**Utah Lake Drainage Basin
Water Delivery System
Bonneville Unit, Central Utah Project
Final Environmental Impact Statement**

Errata for:

September 2004

UTAH RECLAMATION
MITIGATION
AND CONSERVATION
COMMISSION

Figure 2-1
 Utah Lake Distribution Plan
 Monthly System Storage Conversion Line

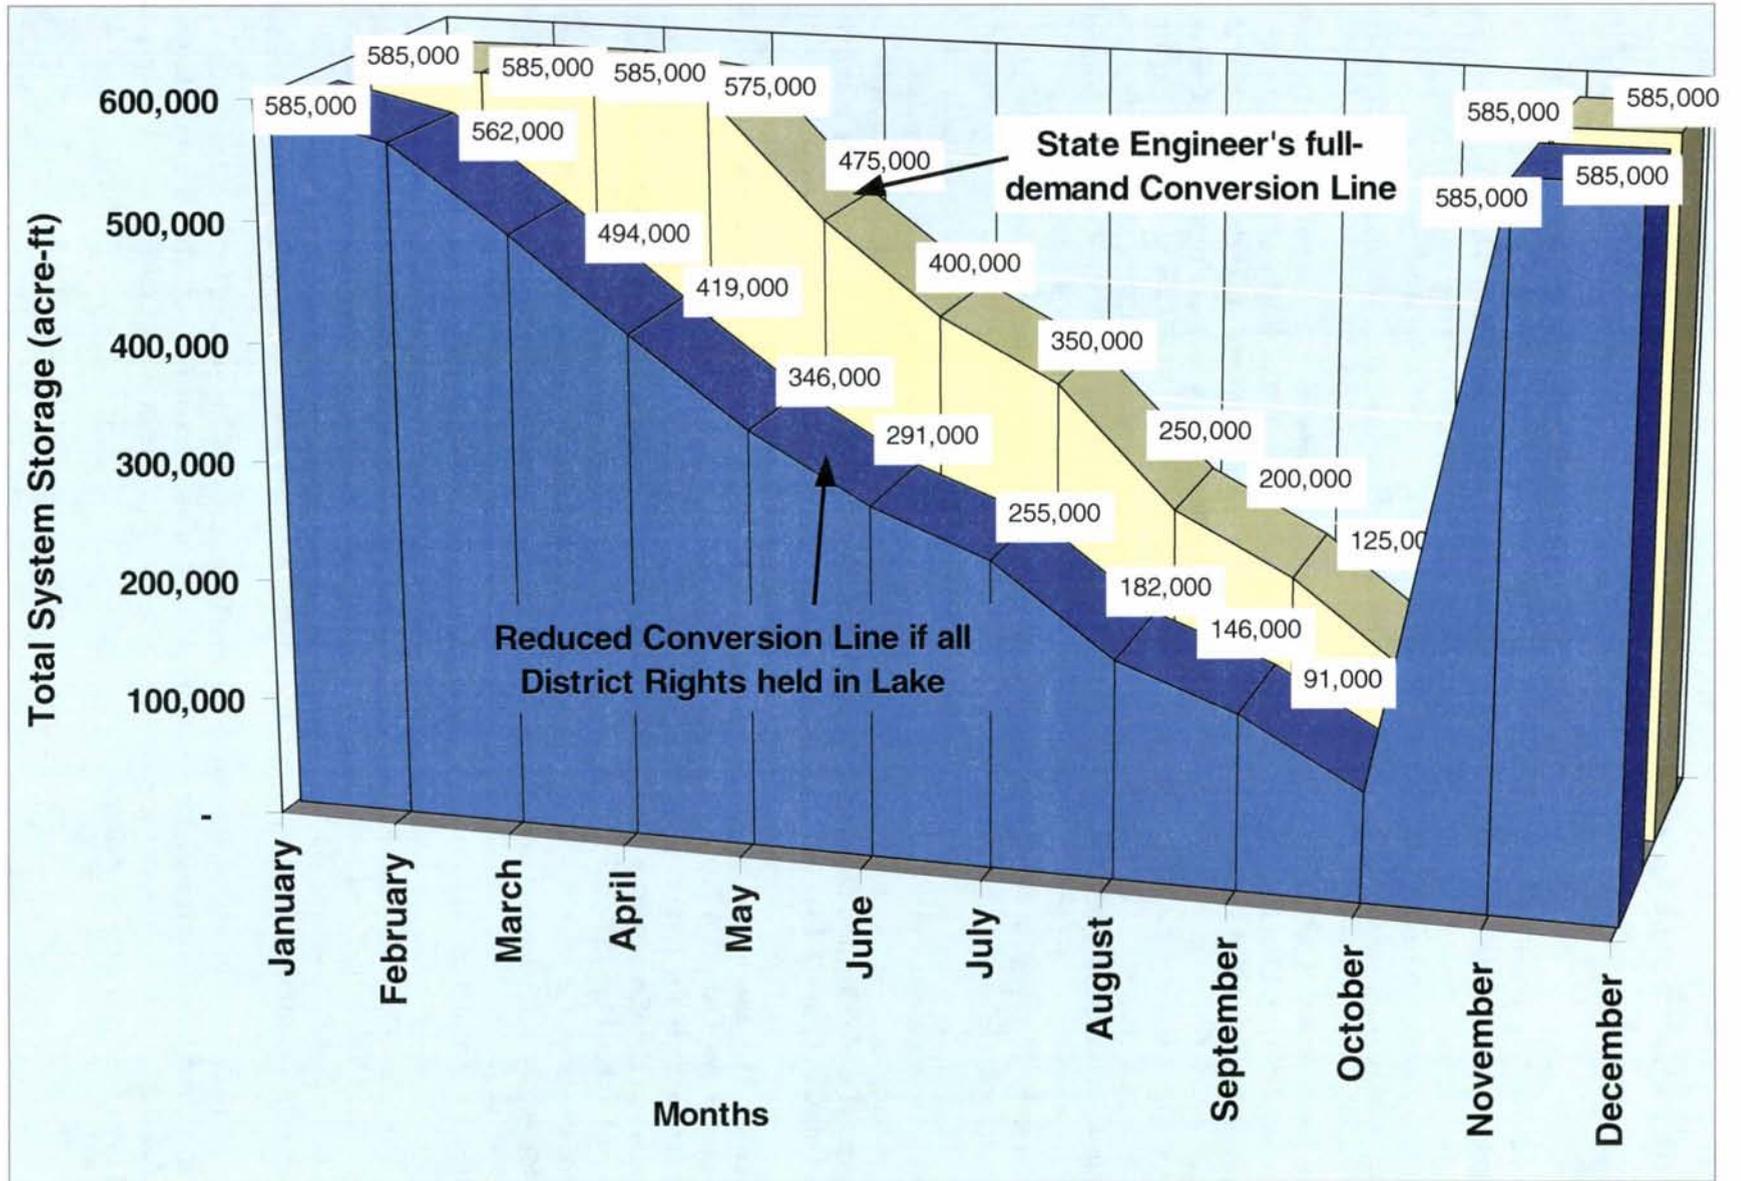
Volume 1, page 15, paragraph 1, Section 2.1.1, change to read:

conversion line shown on Figure ~~2~~ 2-1 represents a lower operational level in Utah Lake under which conversion of system storage in Jordanelle and/or Deer Creek Reservoirs would be possible. Under the ~~Preferred Alternative~~ Proposed Action, DOI would acquire some of the District's secondary water rights in Utah Lake, which as explained above would be exchanged to Jordanelle Reservoir, thereby reducing the amount of replacement water from Strawberry Reservoir needed for the Jordanelle exchange. As a result, this additional quantity of CUP M&I water from Strawberry Reservoir would now be conveyed and delivered directly through ULS facilities to municipal users.

Volume 1, Section 2.1.1, insert Figure 2-1 to follow page 15:
